Access Compliance Report

Public Rights-of-Way

(Pedestrian Signals)

Intersection ID: N/A	Main Street:	Cross Street: N/A	Location: N/A
ADA ID: 32773AAC1CBA	Signal Type: Two Push Buttons-APS	Overall Compliance: No	Severity Score: BTN 1:N/A BTN 2: N/A No BTN: N/A
Codes/Mitigation Info/Possible Solution		Field Measurements/Component Compliance

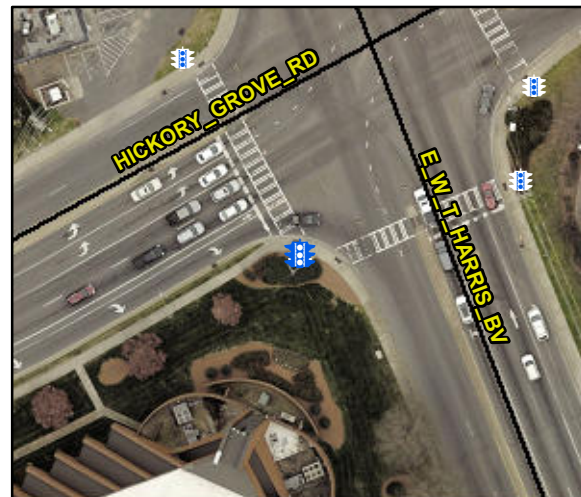
Surveyor Notes: B1 TEXT HT 3/8, B2 TEXT HT 1/2

PROW/ADA: R410.6, TMUTCD 4e.08, R404.2, R406.2, R209.1, TMUTCD 4e.10, MUTCD 4e.08, R104.2, , R404.7.3

Possible Solutions: Replace Signal Push Button With APS Button on New Post. Remove & Replace Sign.
